SERVICE BULLETIN

APPLICABILITY: 2015-16MY Outback Models

NUMBER: 12-208-16

SUBJECT: Improvement to Power Rear Gate (PRG) Operation

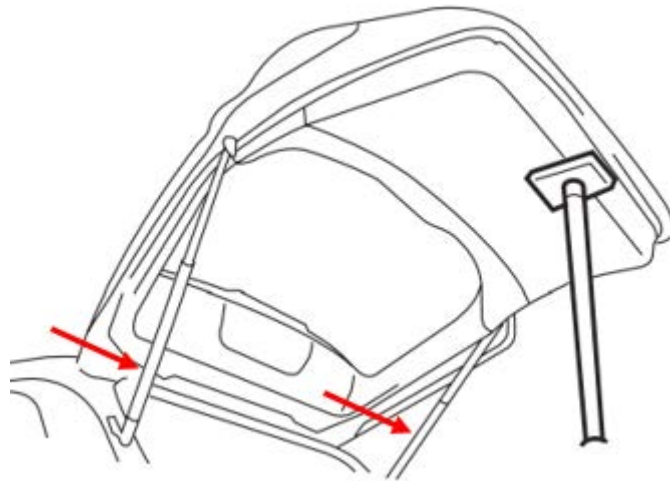
CAUTION: Whenever removing / replacing the rear gate stays, always work in teams of 2 or more people due to the weight of the rear gate assembly. Whenever a stay is removed, always use a securely positioned prop as shown in the illustration below to keep the rear gate open and supported. Vehicle damage and/or personal injury may occur should the prop become disengaged unexpectedly.
